Descriptive Report to Accompany Hydrographic Survey H11053

Project OPR-O327-RA-01
Northern Clarence Strait and Zimovia Strait, Alaska
Scale 1:10,000
April-May 2001
NOAA Ship RAINIER
Chief of Party: Commander Daniel R. Herlihy, NOAA

Revisions Compiled During Office Processing and Certification

Figure 2. H11053 Junction Survey

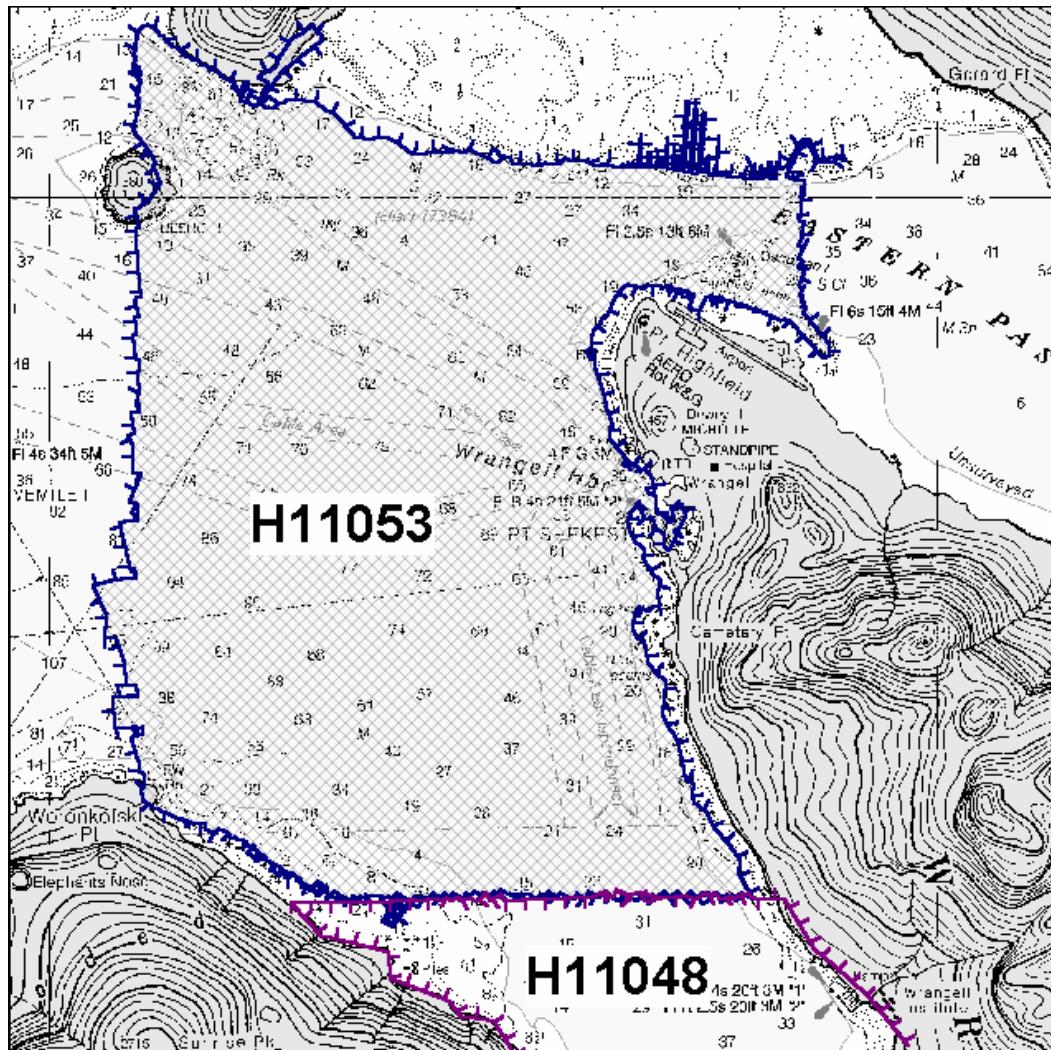
Survey H11048 junctions well with this survey, with differences generally less than one fathom.¹³

Final comparisons will be made at the Pacific Hydrographic Branch (PHB) after the application of smooth tides.¹⁴

¹³ The junction between surveys H11053 and H11048 was accomplished during office processing of survey H11171.

The junction is complete and differences are generally less than one fathom.

¹⁴ Concur, the junction is complete after the application of smooth tides.

Chart 17384
Kodiak

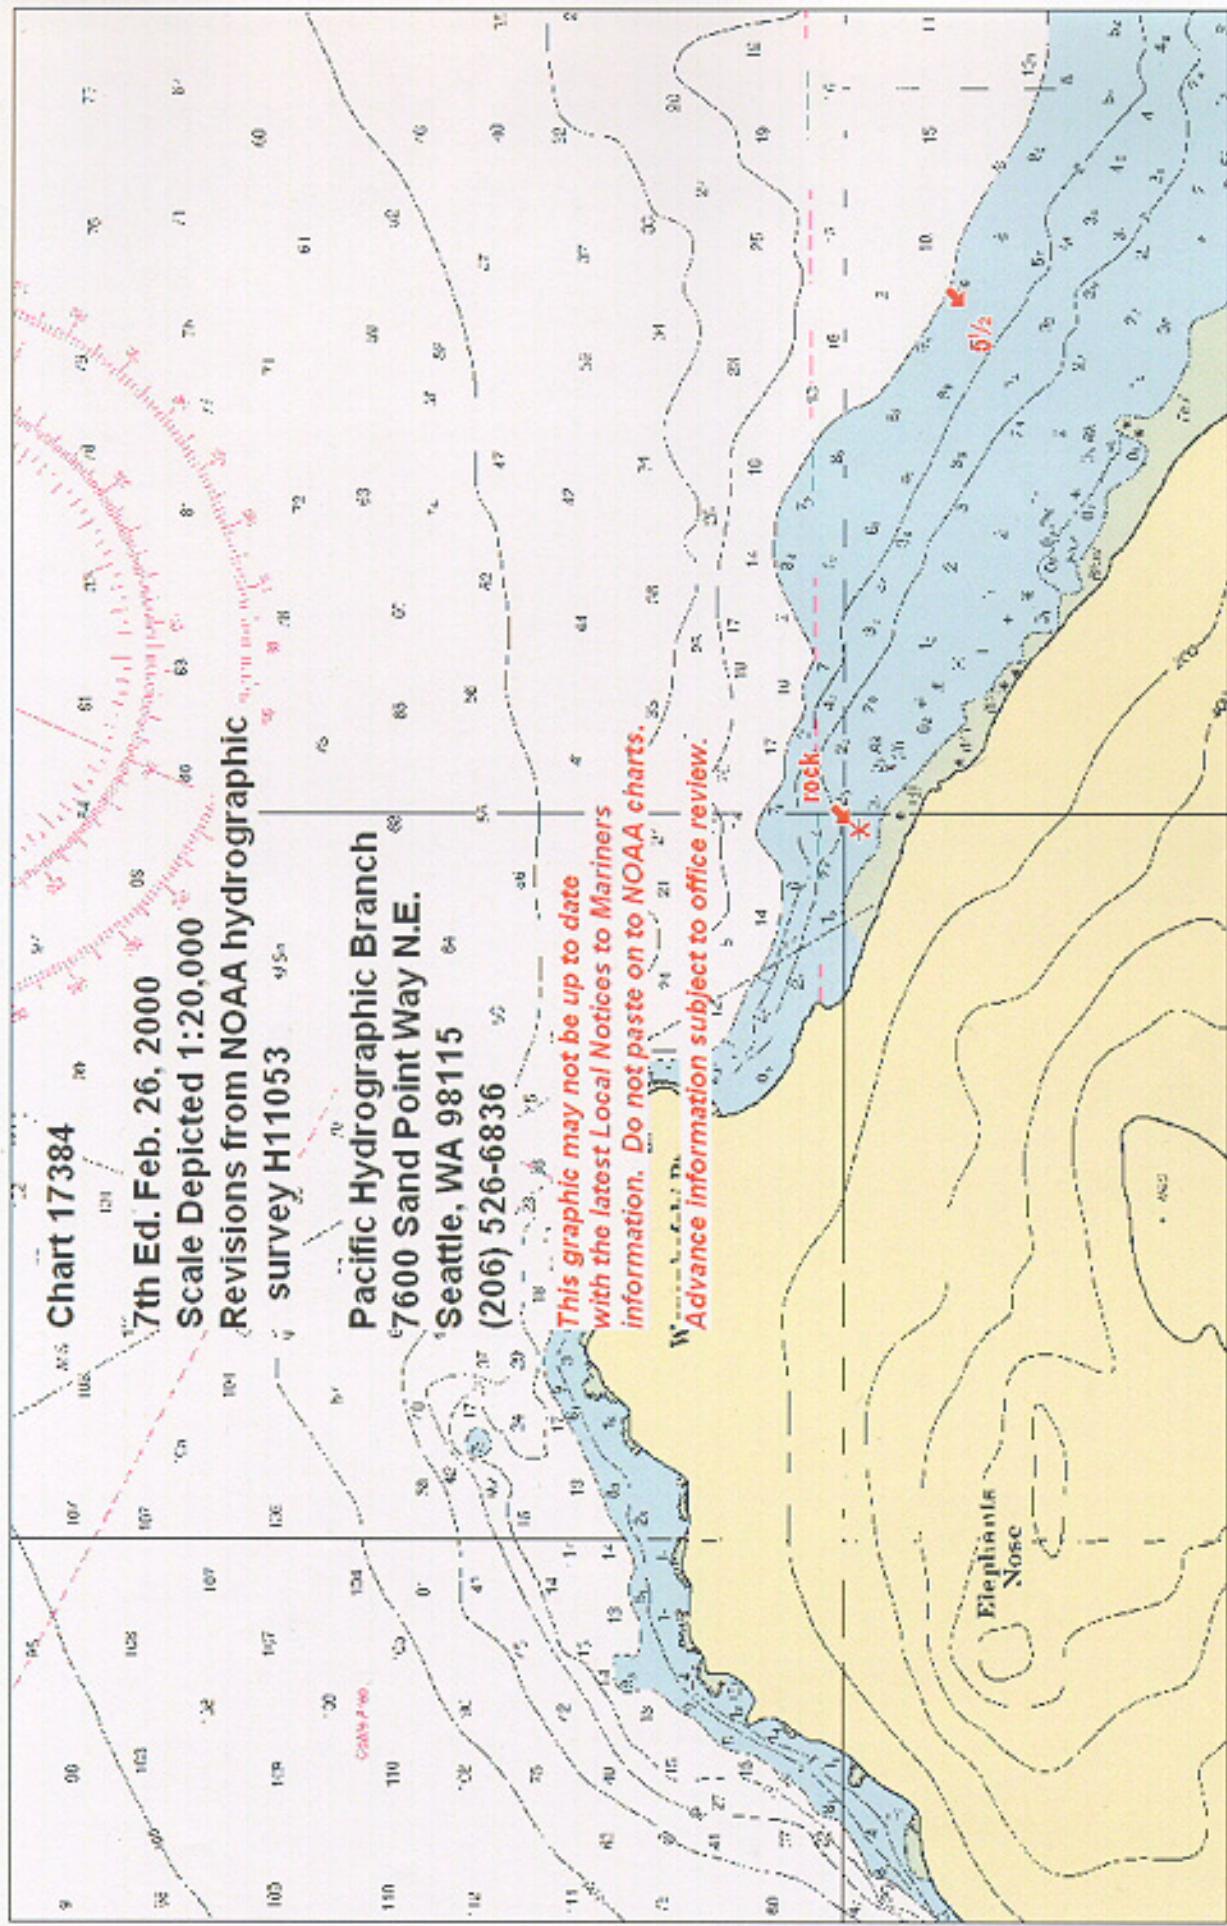
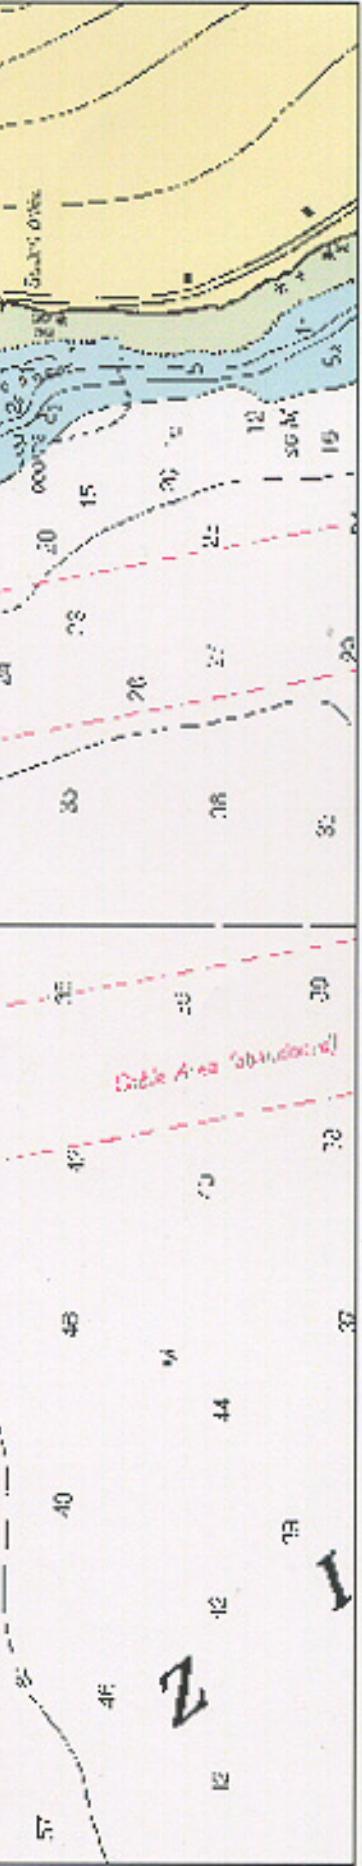
While conducting hydrographic survey H11053 in April of this year in the vicinity of Wrangell Harbor and the Stikine River, NOAA Ship RAINIER found that the mud flats at the mouth of the Stikine River have migrated approximately 500 meters seaward. As a result, survey depths are as much as 20 fathoms shoaler than charted depths. It is recommended that this information be included in the Local Notice to Mariners as a danger to navigation. It is also recommended that mariners use extreme caution when navigating this area due to the changing nature of the river mouth.

The attached chartlets depict the seaward migration of the shoal and the approximate revisions to charted contours. The complete hydrographic survey will be completed later this year and applied to chart following final office review.

⁶¹ The evaluator recommends a caution note be added to chart 17384 in the vicinity of the Stikine River, see smooth sheet and Hdrawing.

⁶² The Danger to navigation letter was reviewed at the Pacific Hydrographic Branch and six dangers were forwarded to the U.S. Coast Guard on November 27, 2001. See attached copy.
